From: [REDACTED]
To: [SizewellC](#)
Subject: Discretion to accept a submission.
Date: 06 November 2020 08:44:44
Attachments: [Sizewell C – 1 DCO Response. The environment, coastal morphology and climate change-a 2020 perspective.pdf](#)

Sizewell C – Development Consent Order Response. The environment, coastal morphology and climate change - a 2020 perspective

This paper is a response to EDF's Sizewell C Flood Risk Assessment (FRA) and approach to shoreline and offshore geomorphology as presented in the Development Consent Order (DCO) application. The following are my summarised conclusions and recommendations:

Figure 1: Projection for 1:10,000 year flood event (still water) with the H++ sea level rise of 1.9m showing hazard rating. Red is extreme hazard.

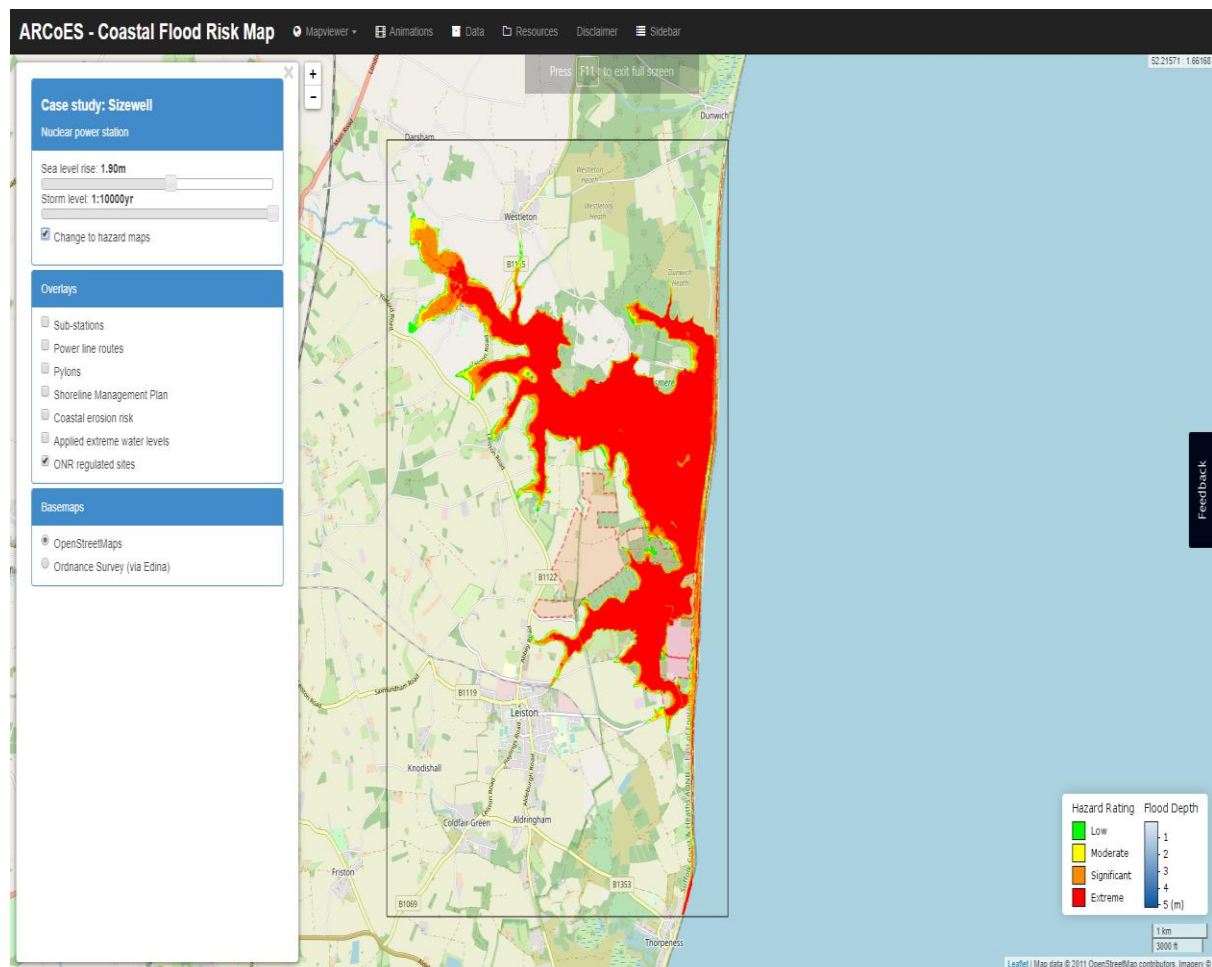
The ARCoES chart in Figure 1 above represents an H++ scenario of the 'extreme' water level of 4.21m plus the forecast sea-level rise by 2100 of 1.9m which I understand to be the level that EDF must design to meet 'the Nuclear Safety Case'. The chart, as stated, does not consider any wave action, which would be additional.

Figure 2. The Sizewell-Dunwich Banks. The purple arrows mark 26700N— to the north of which the crest height of Dunwich bank is lowering.

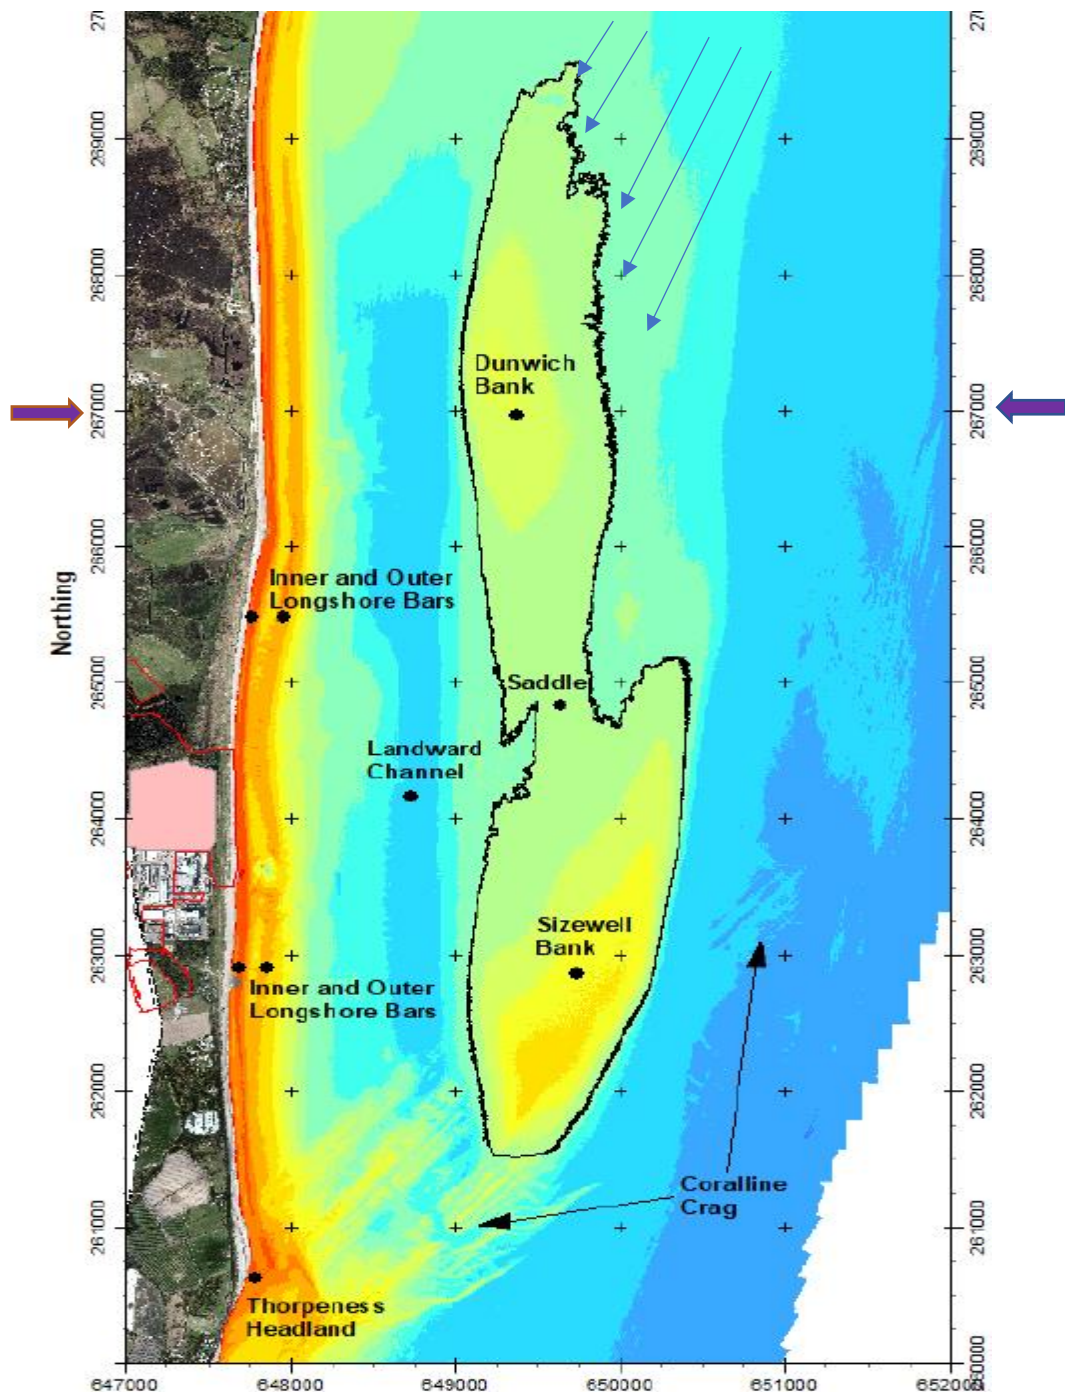
It is also my view that it would not be plausible to consider the loss of the Dunwich bank as compatible with the retention of the nearshore, longshore bars. See Figure 2 in this section.

Figure 2 below illustrates the Sizewell Dunwich banks and references the points made in the above discussion.

- The ‘three positive relief features’ as suggested by EDF in the DCO. The orange and red lines show the ‘inner and outer’ nearshore, longshore bars, now regarded in the DCO as significant relief features. The DCO provided detailed bathymetry of the inner and outer Longshore bars and not the Sizewell-Dunwich banks.
- The pink square shows the proposed location of Sizewell C.
- *“Records over the last decade show...Dunwich Bank exhibited greater variability in both its morphology and position with erosion north of 267000N, [shown by the*

- The five blue, fine arrows show the direction of the most significant storm waves from the North/North East— **the largest and longest waves arrive from the N-NE sector. [1:100 wave heights 7.3m-7.8m]**. DCO: Geomorphology Appendix 20A. op.cit., Paragraph 2.3.2.2.2
